**RE: View House Apartments
540 Paisano Ct. NE
Grading and Drainage Plan
Engineer's Stamp Date: 1/17/22
Hydrology File: D17D074**

Based upon the information provided in your submittal received 1/4/2022, the Grading & Drainage Plan is **not** approved for Building Permit. The following comments need to be addressed for approval of the above referenced project:

CG-100

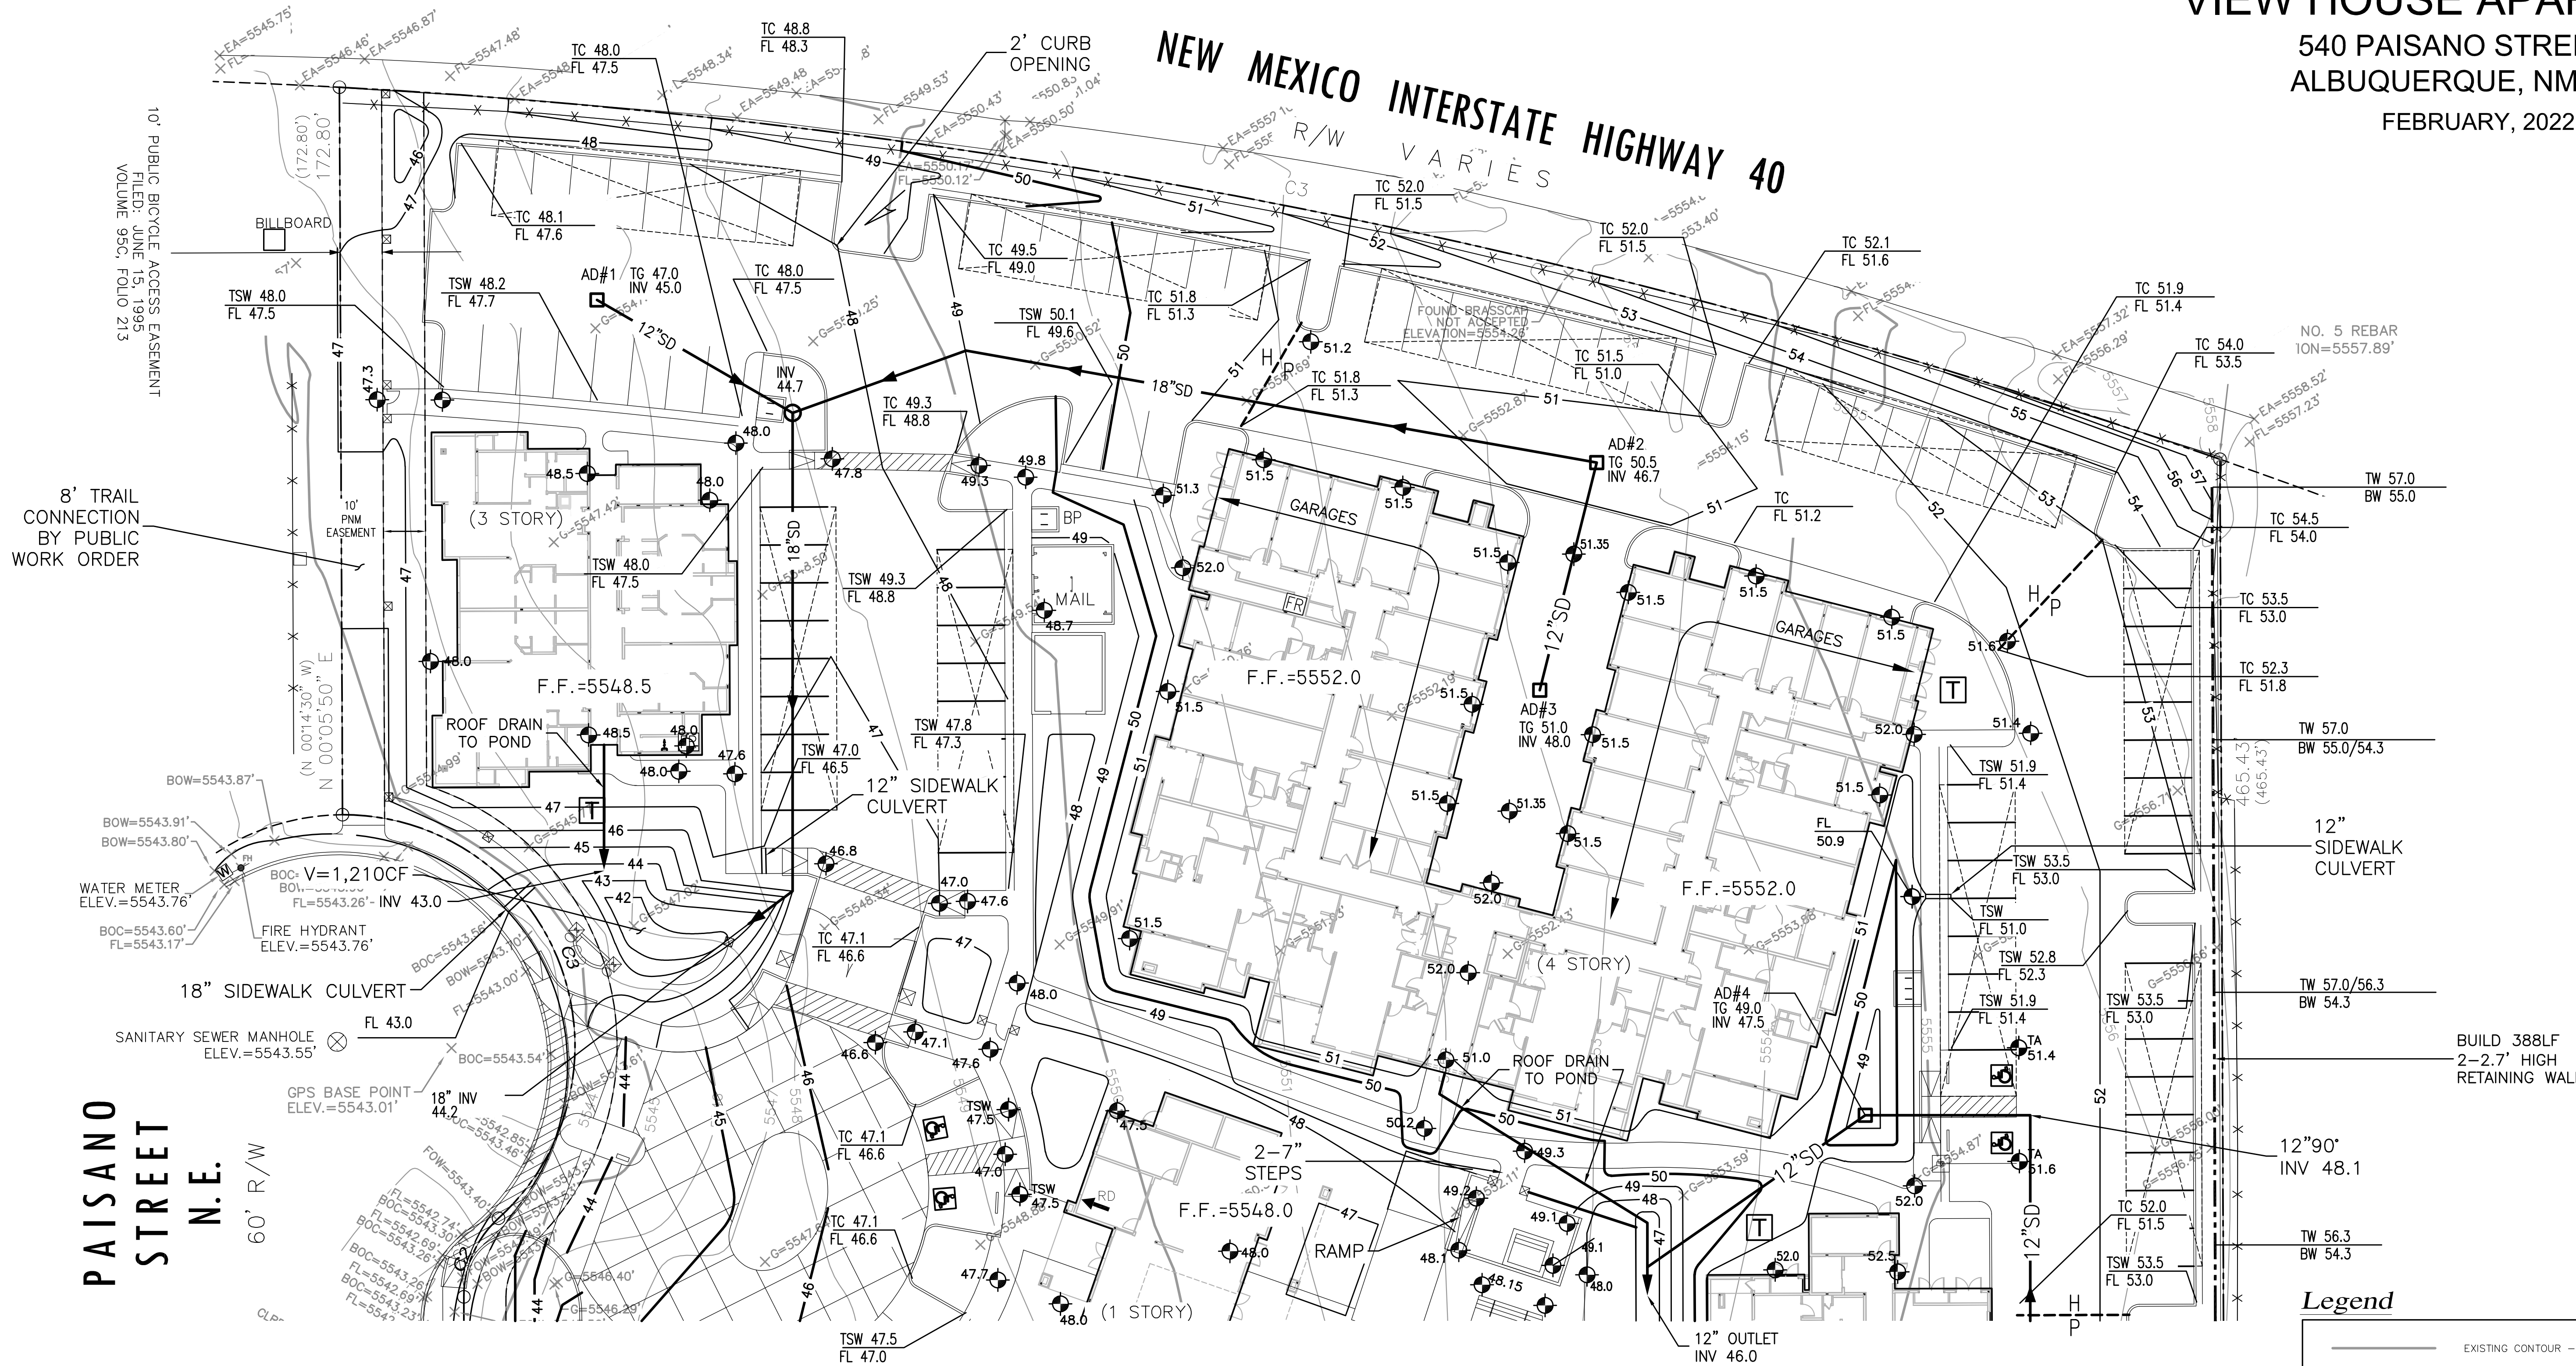
4. Please include all necessary background calculations used to determine resulting flows for existing and proposed.
5. Some of language is cut off on the bottom of the sheet CG-100.
